EPC STORMWATER REVIEW COMMENTS ARE SHOWN IN ORANGE BOXES WITH BLACK TEXT

THE LANDINGS OF DENMARK FILING NO. 2 COUNTY OF EL PASO, STATE OF COLORADO CONSTRUCTION PLANS

Construction Drawings (PlansProfiles)_v1.pdf Markup Summary

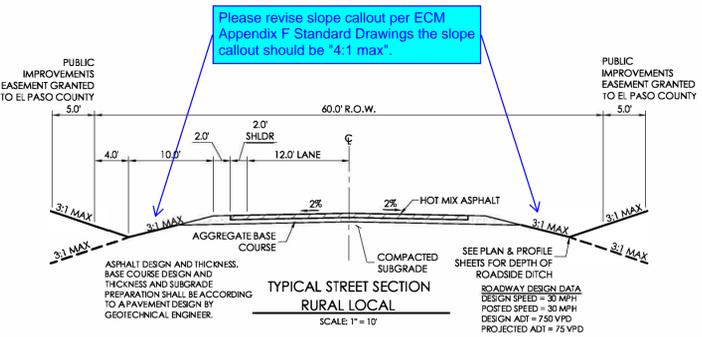
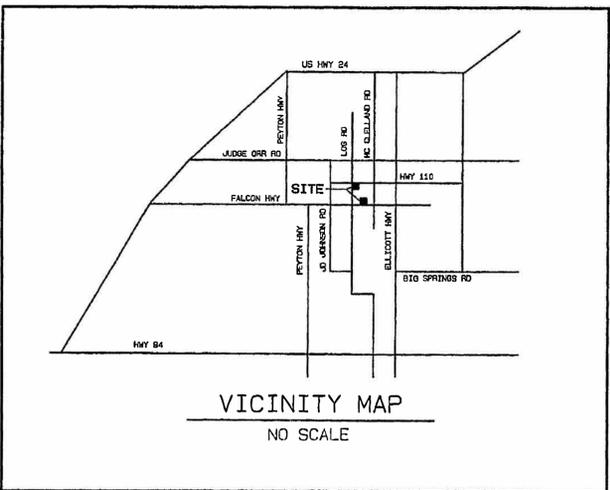
Include basis of bearings and benchmark

Please revise slope callout per ECM Appendix F Standard Drawings the slope callout should be "4:1 max".

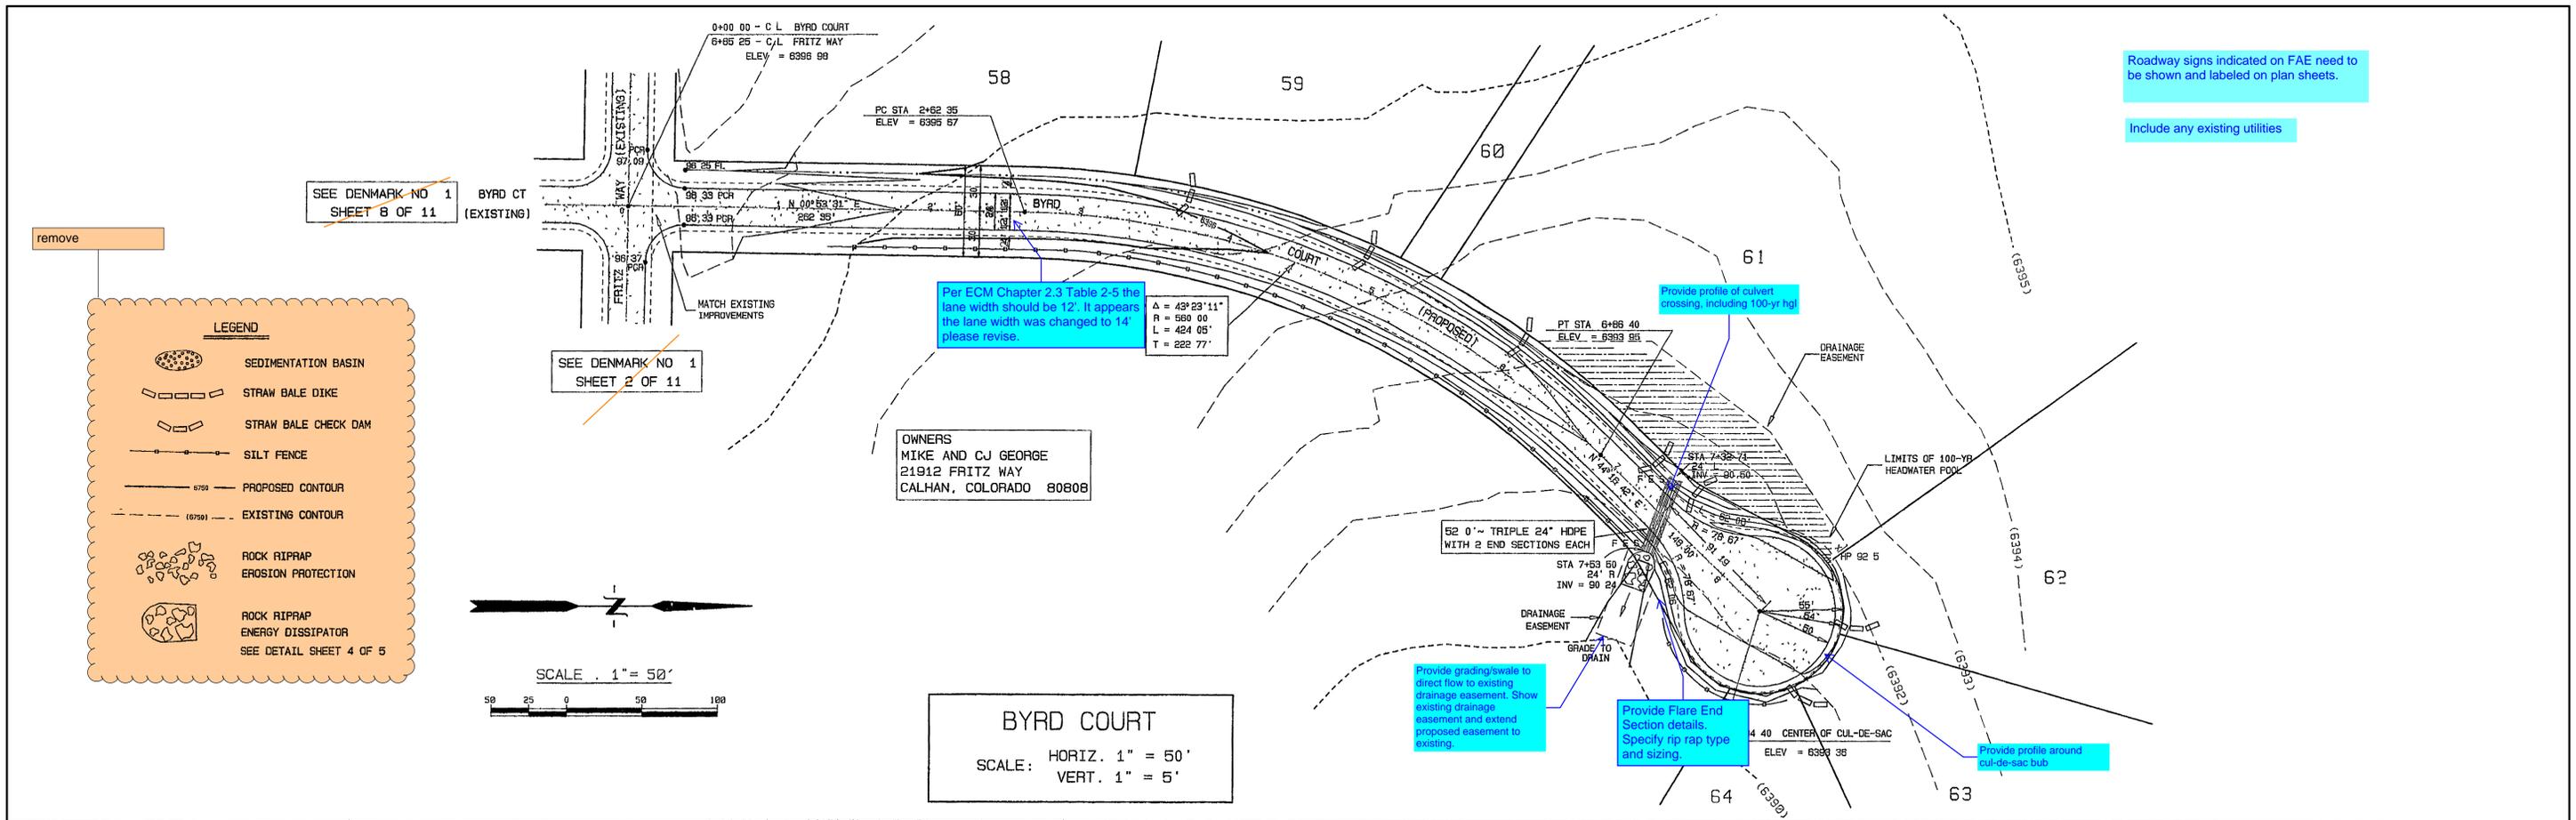
Roadway signs indicated on FAE need to be shown and labeled on plan sheets.

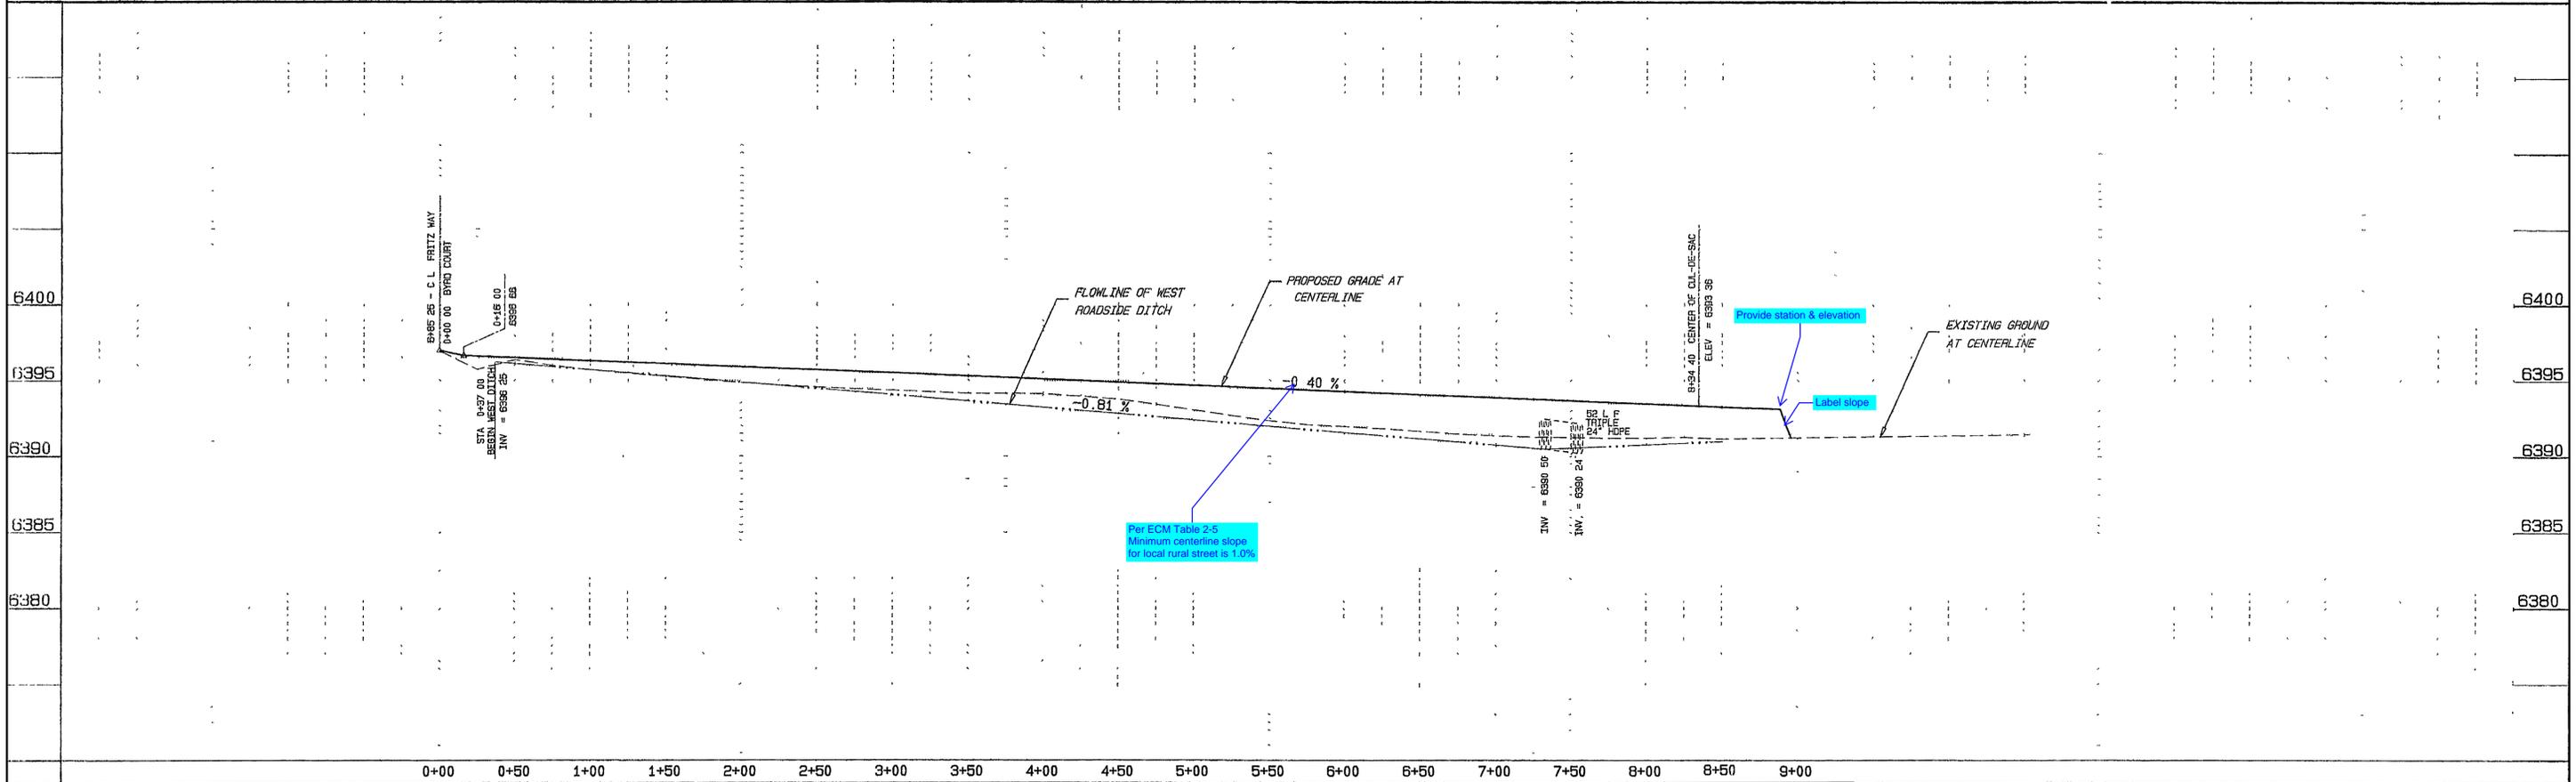
Include any existing utilities

O'STEEN COURT
 SCALE: HORIZ. 1" = 50'
 VERT 1" = 5'

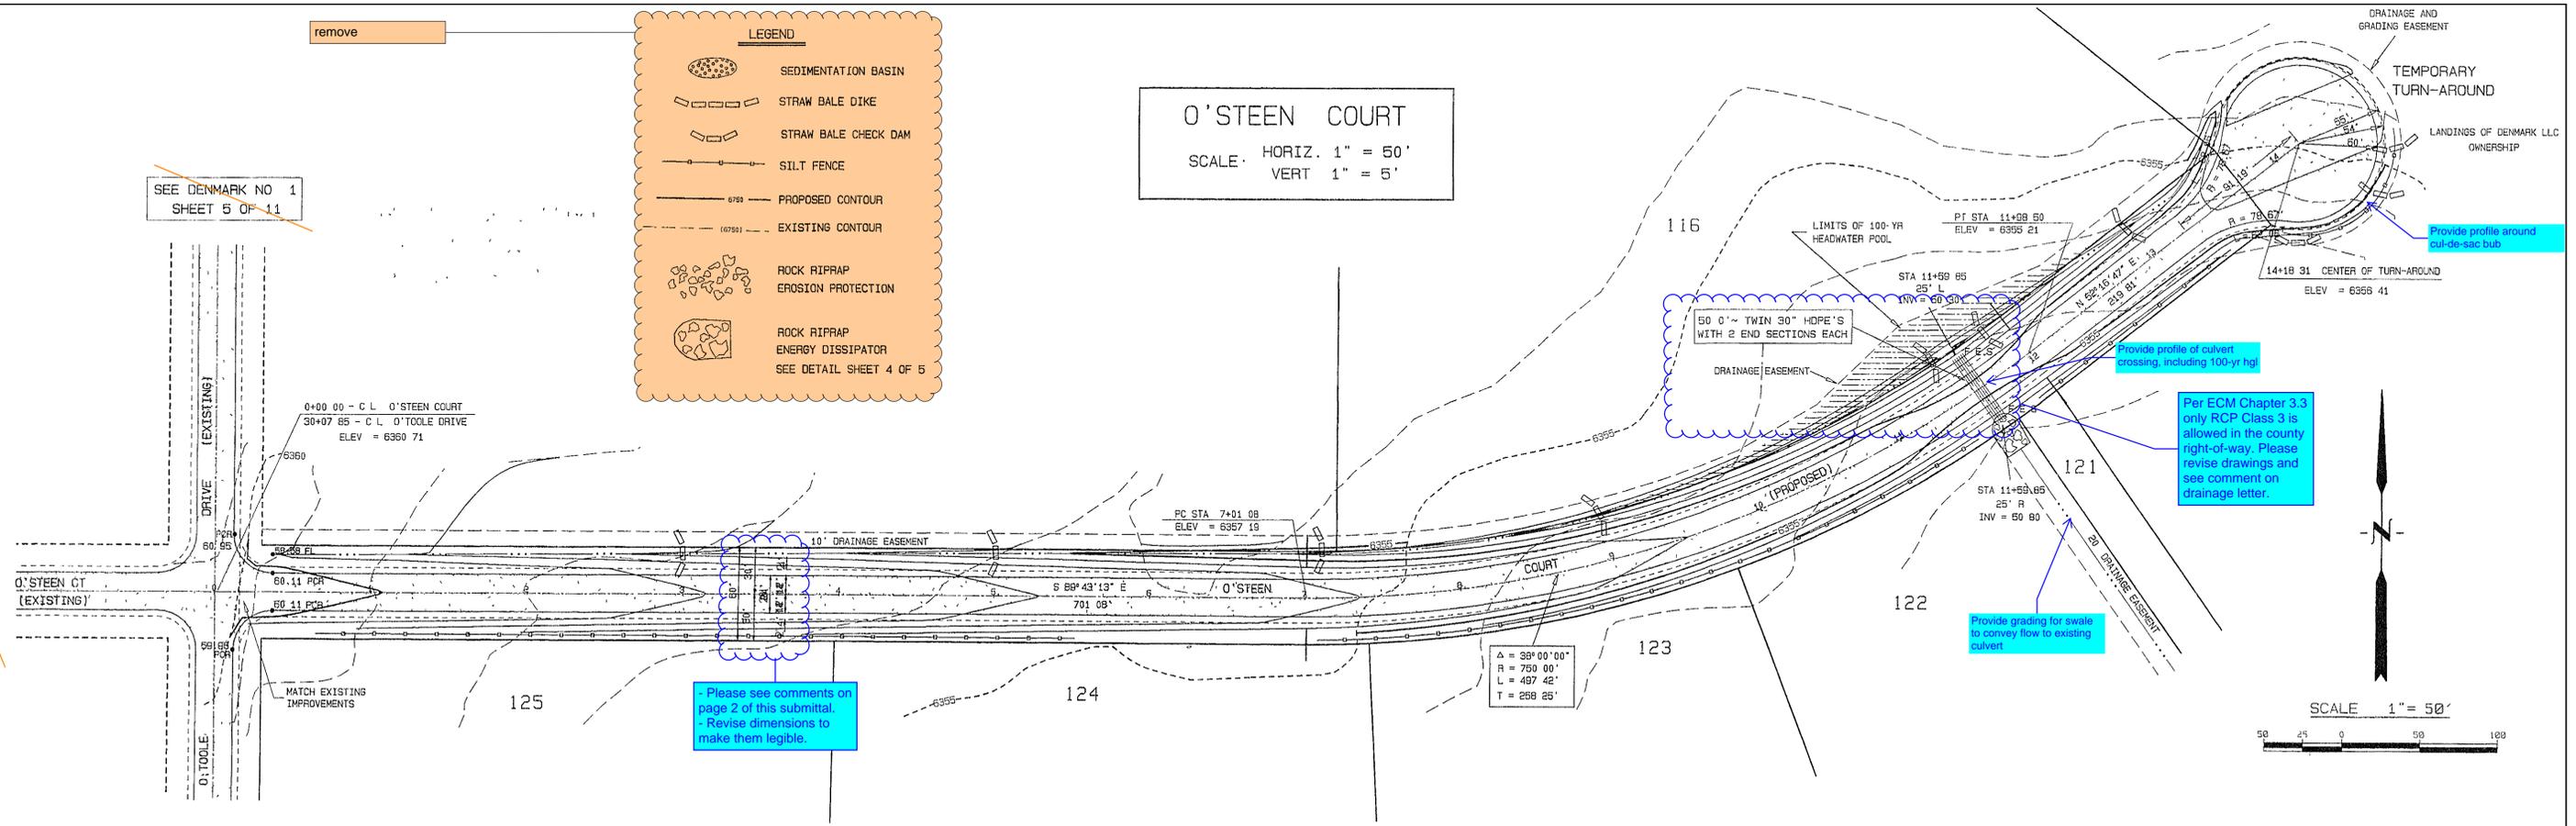
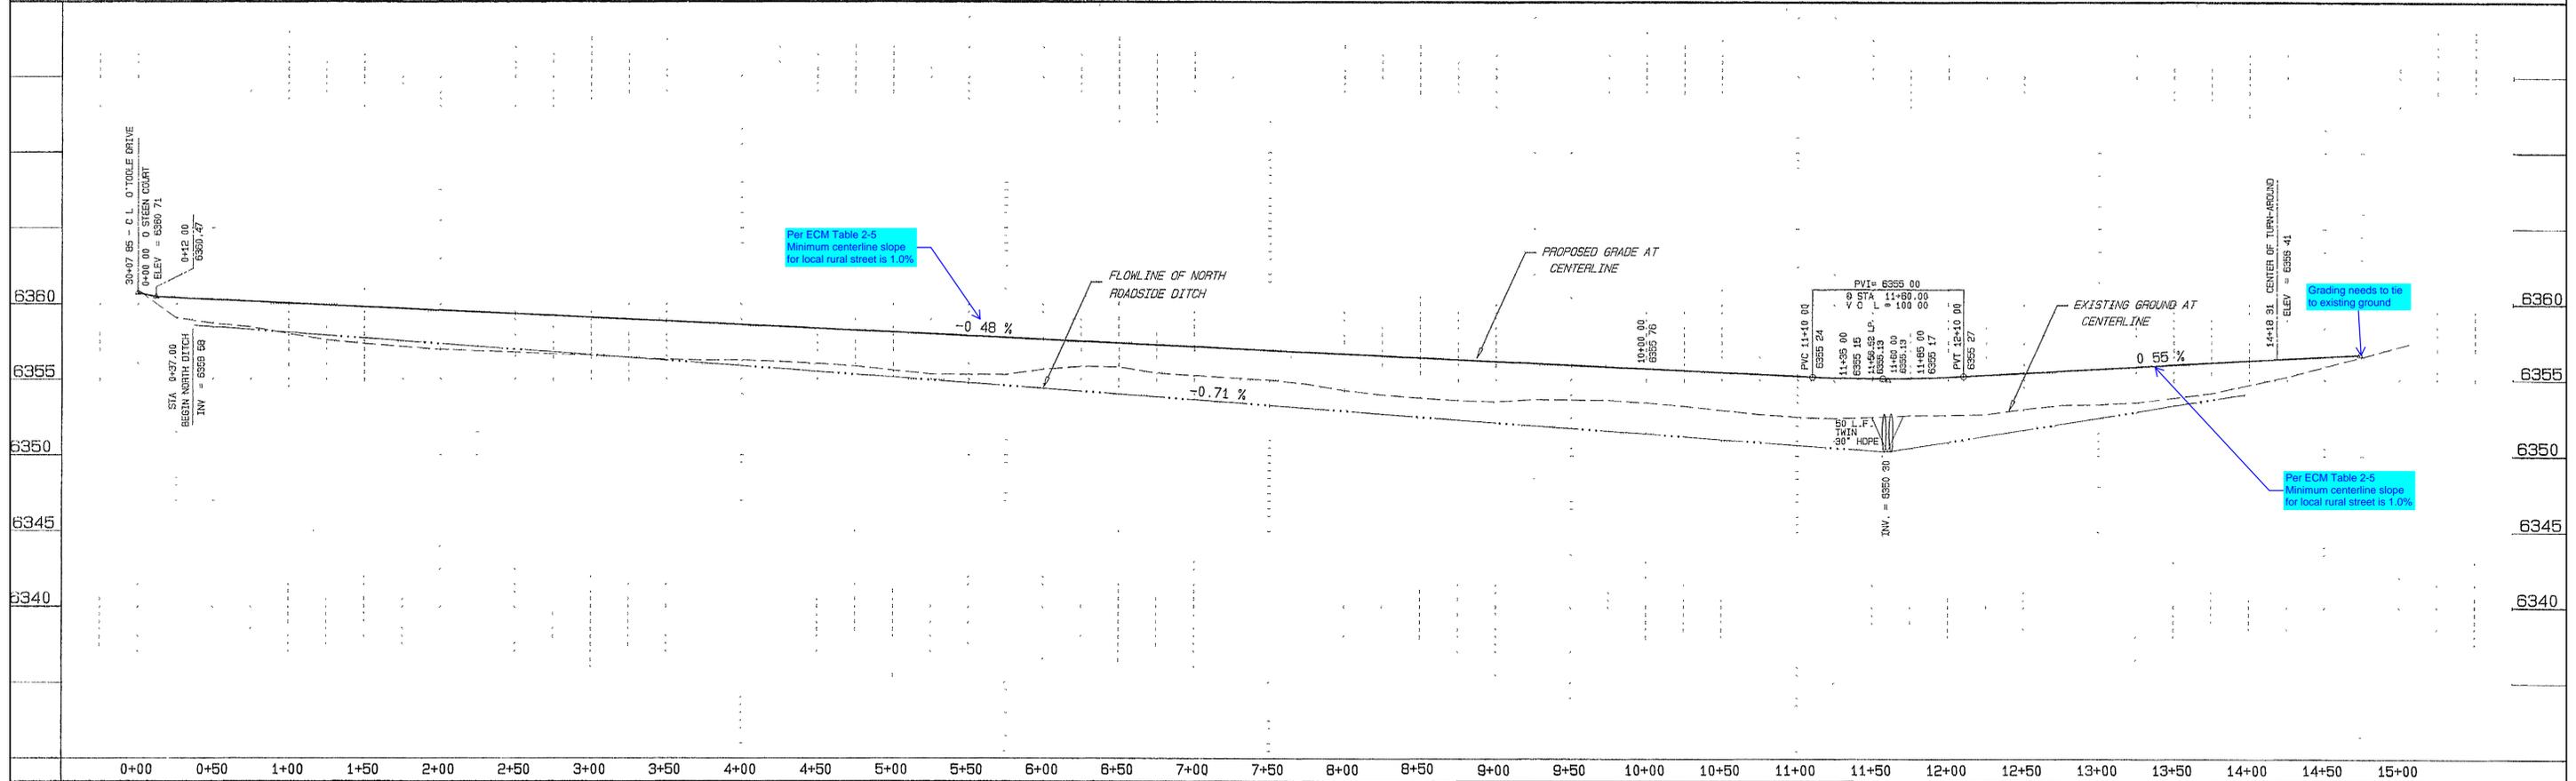
Please see comments on page 2 of this submittal. Revise dimensions to make them legible.

Per ECM Chapter 3.3 only RCP Class 3 is allowed in the county right-of-way. Please revise drawings and see comment on drainage letter.

Provide grading for swale to convey flow to existing culvert

Provide profile around cul-de-sac but

Provide profile of culvert crossing, including 100-yr hgt

Per ECM Table 2-5 Minimum centerline slope for local rural street is 1.0%

Grading needs to tie to existing ground

Per ECM Table 2-5 Minimum centerline slope for local rural street is 1.0%

ROCK RIPRAP ENERGY DISSIPATOR DETAIL
NOT TO SCALE

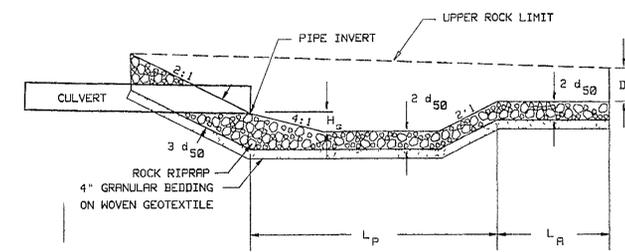
Please show an accurate detail and dissipator sizing for triple 24" pipe and double 30" pipe

Provide riprap gradation table and note that CDOT Section 506 Requirements apply.
